DOCUMENTATION TRANSMITTAL

Documentation Description: Nonconformance Reports -
C-03732
C-03736
C-01006

MIDLAND PROJECT
QUALITY ASSURANCE
DEPARTMENT

NONCONFORMANCE REPORT

Door #77C

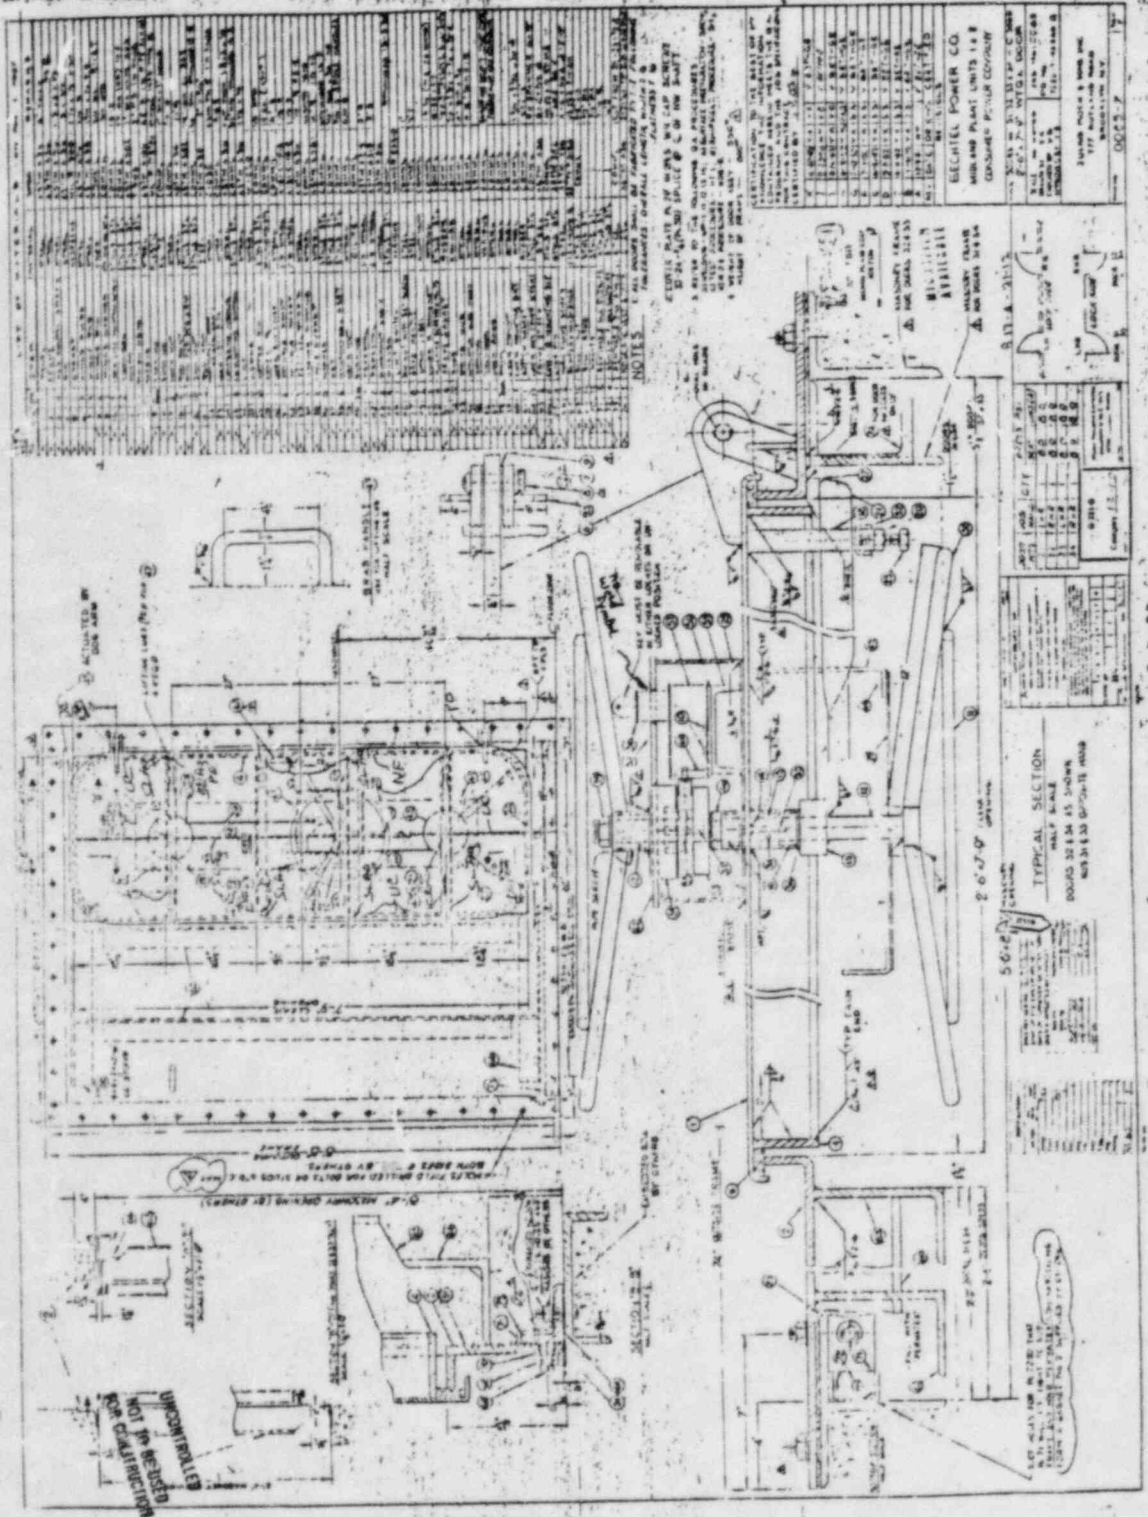
C.R. = cold roll
 L/F = lack of fusion
 C/C = undercut
 4/5 = under size

Door # 32 C

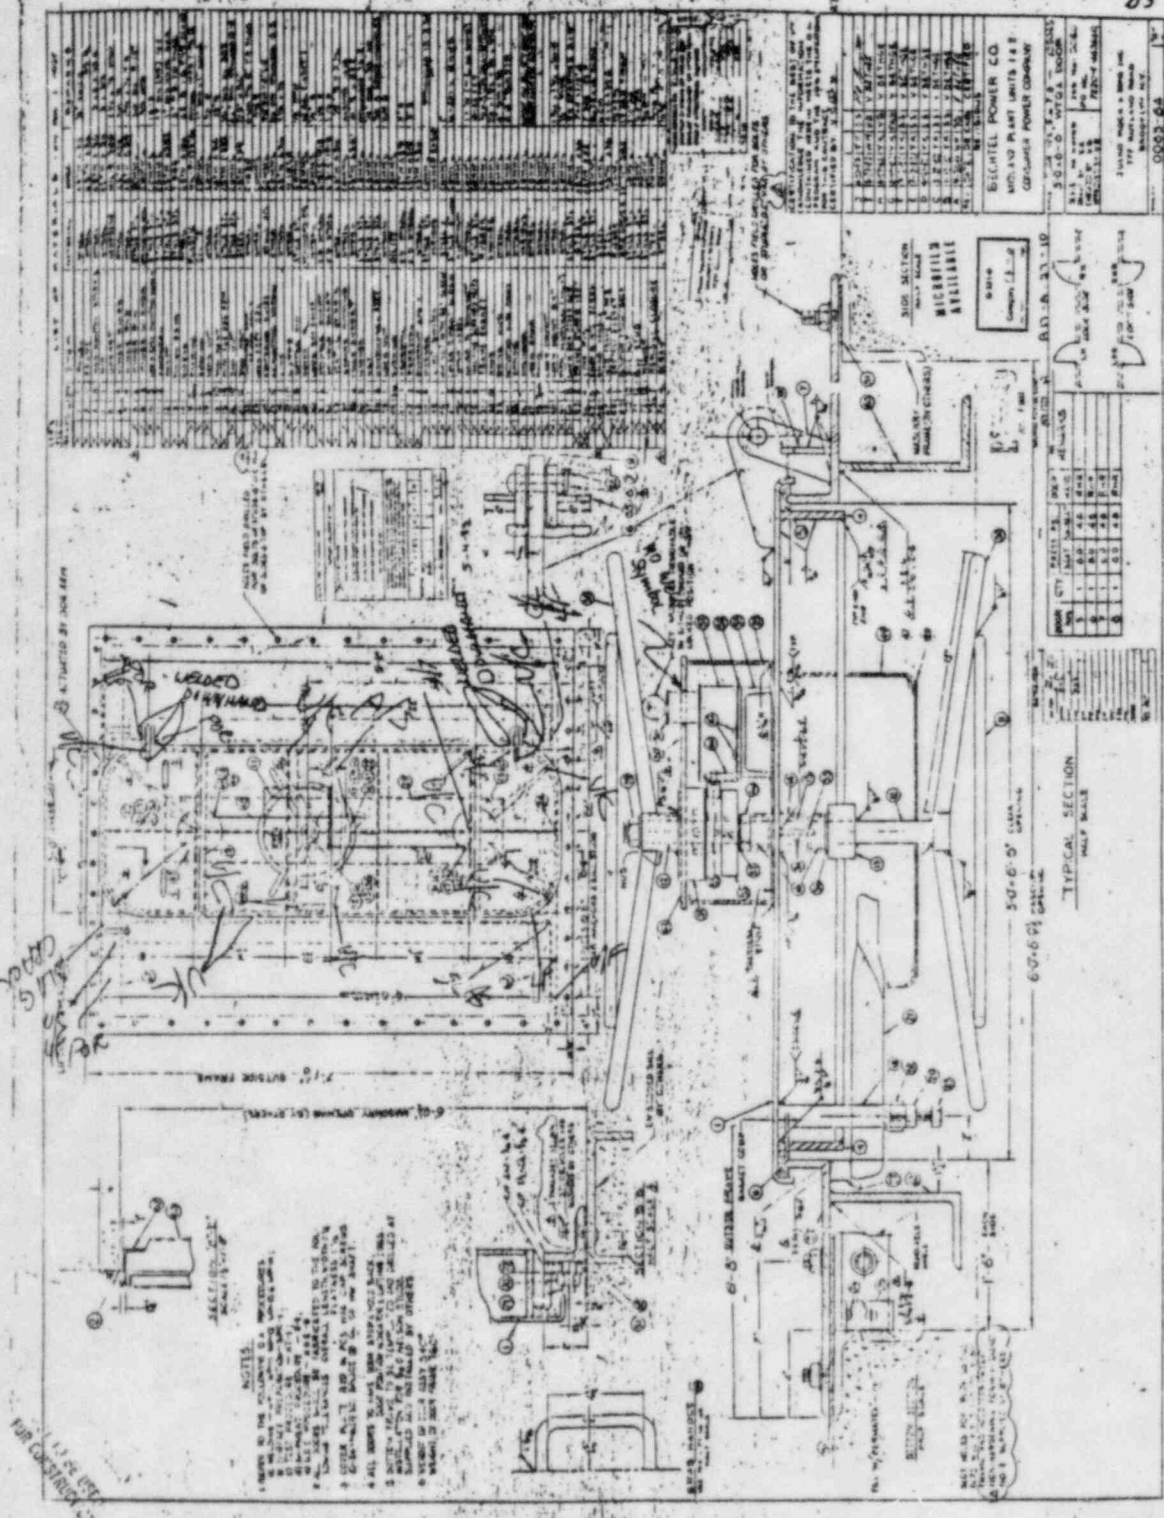
WPC - UNDERWAY
 A/S - ARE STARTED
 WS - UNDER SIZE

Door # 5

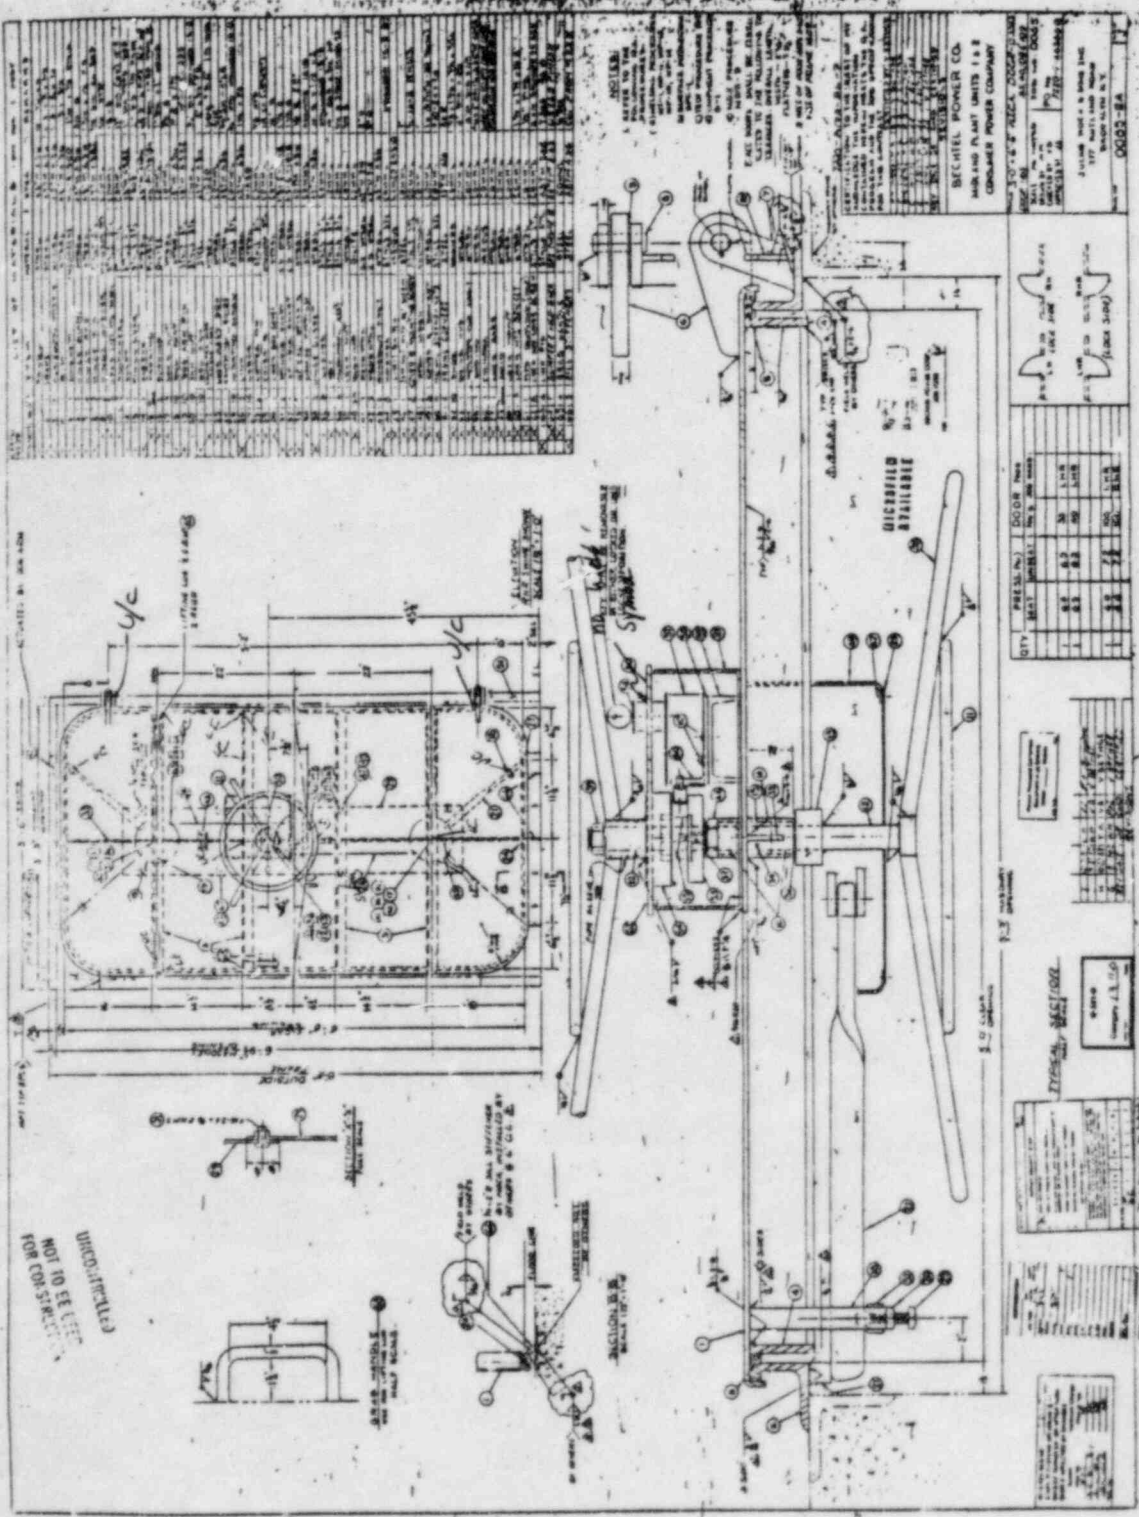
4/c = undercut
 u/s = under size
 c/l = cold lap
 por = porosity
 u/f = underfill

Door # 40 @

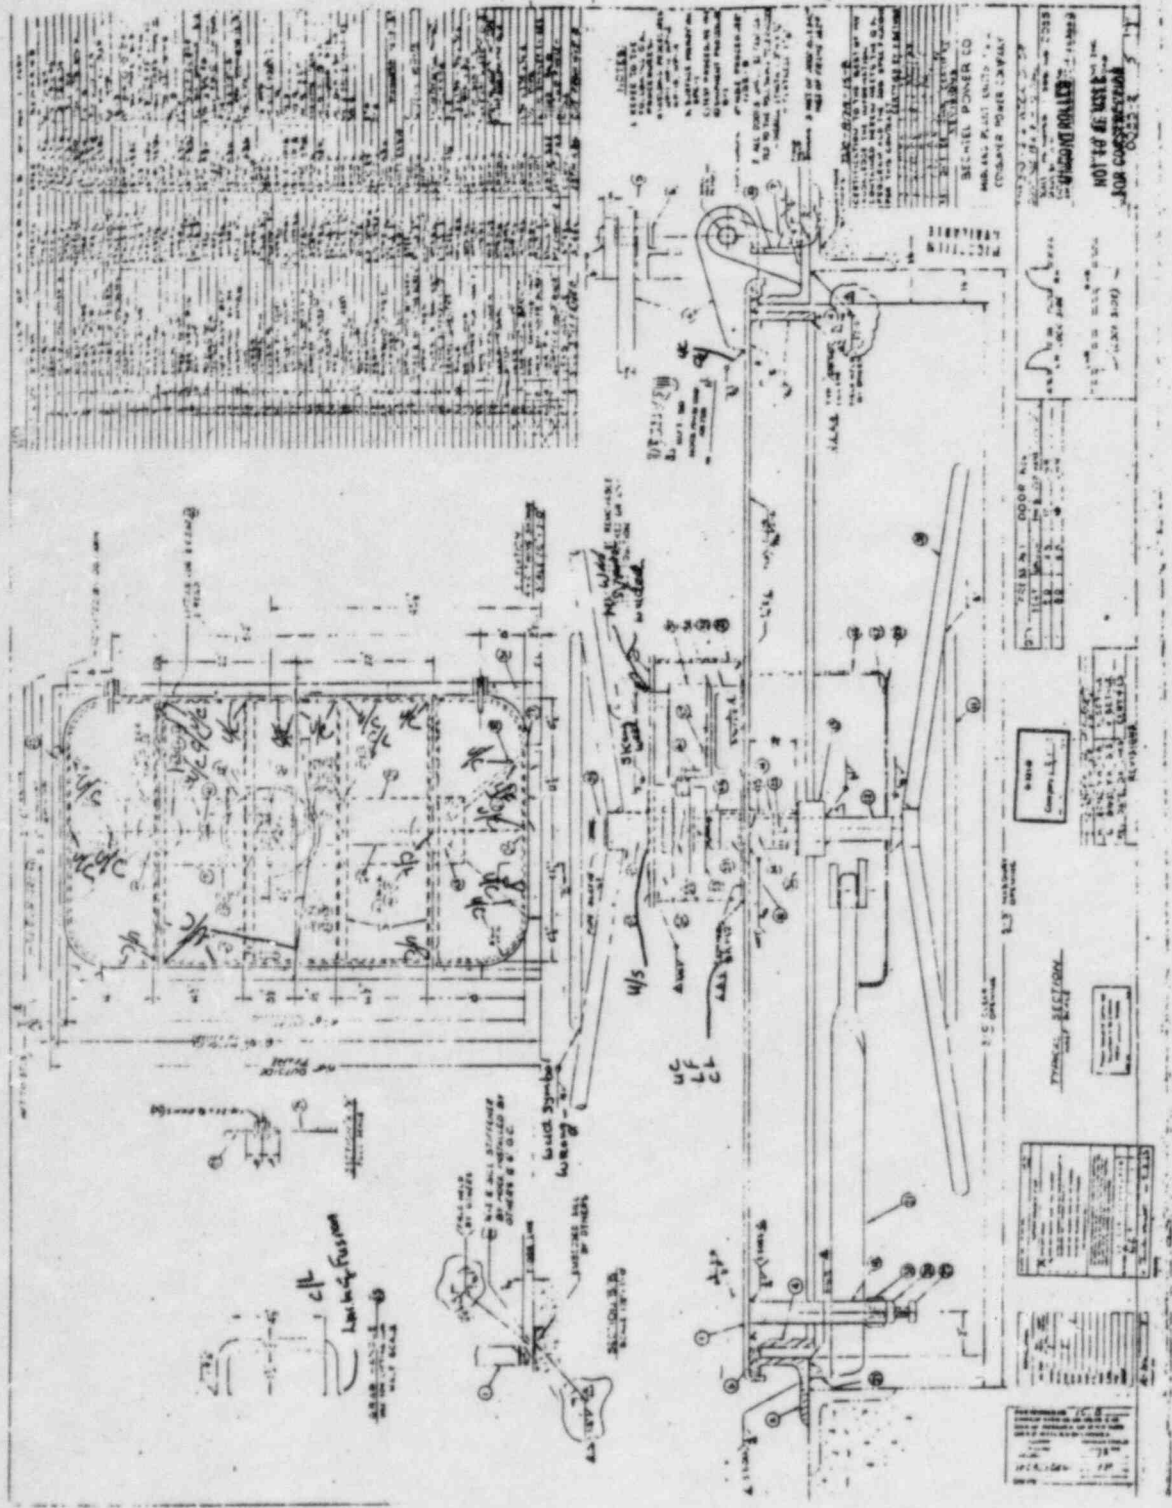
4/c = undercut
 4/s = undercut
 L = list of fusion

Door # 18 (C)

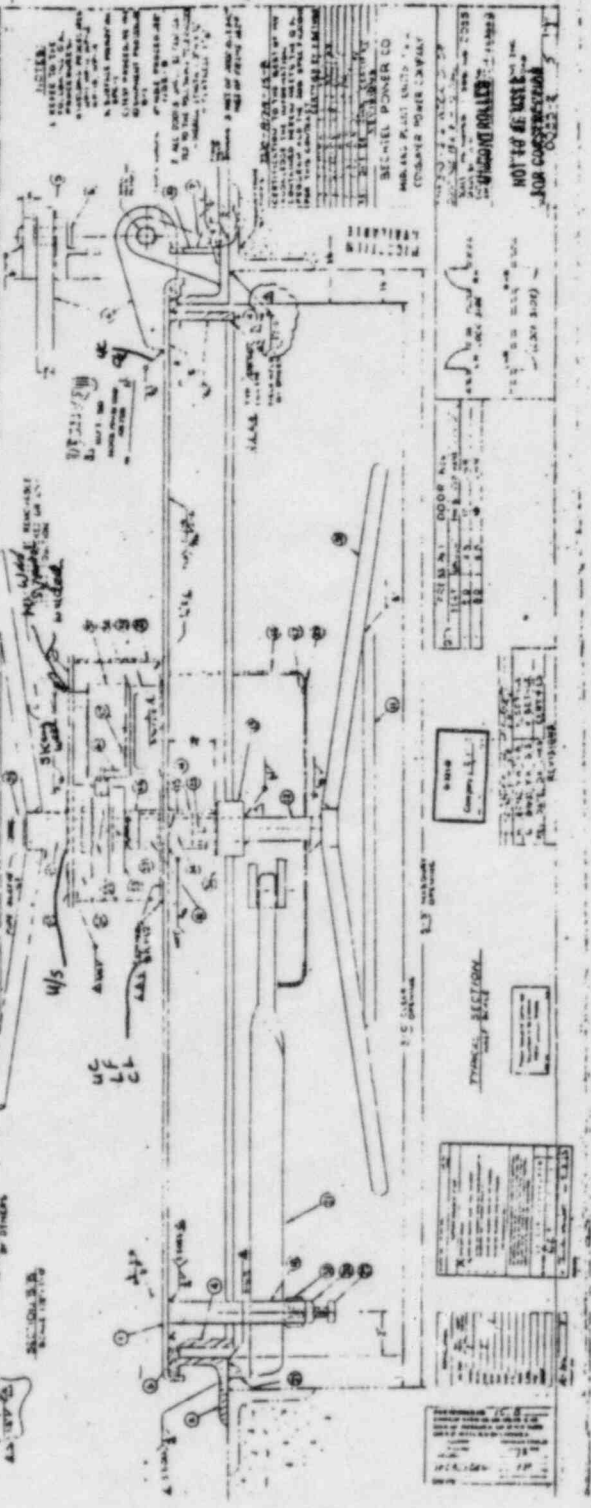
W/C = undercut
L/F = lock of fusion
C/L = cold lap/roll

Door # 6

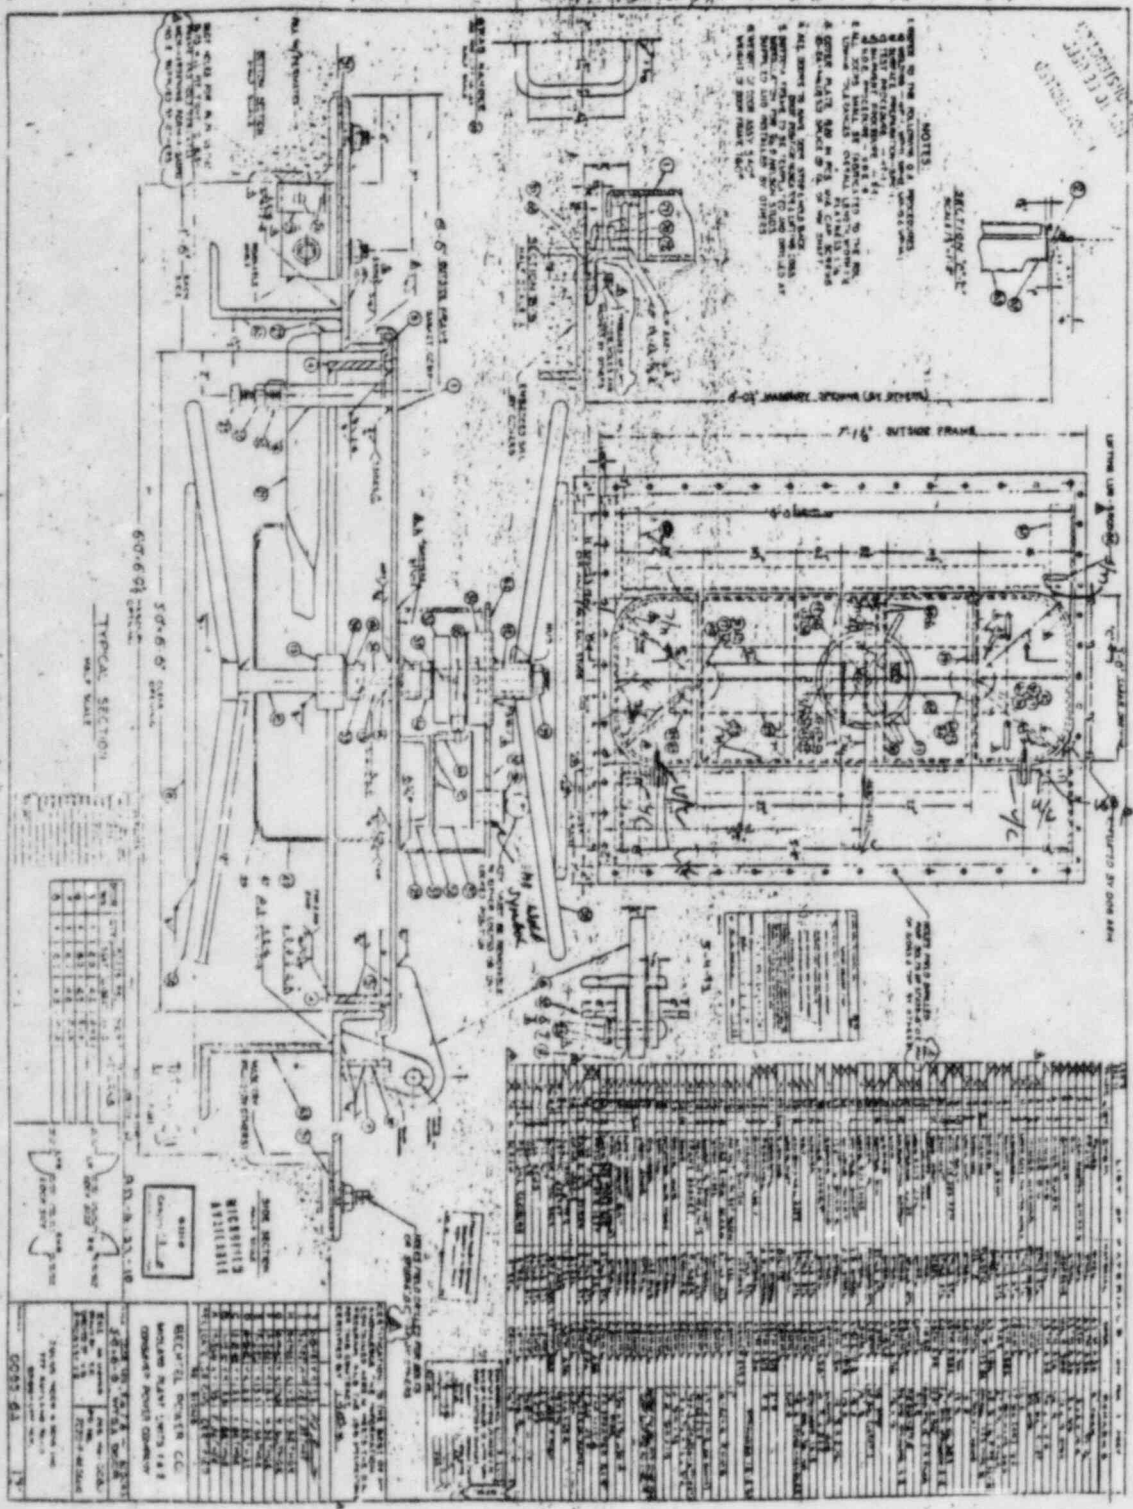
u/c = Undercut
 L/F = Lead Flange
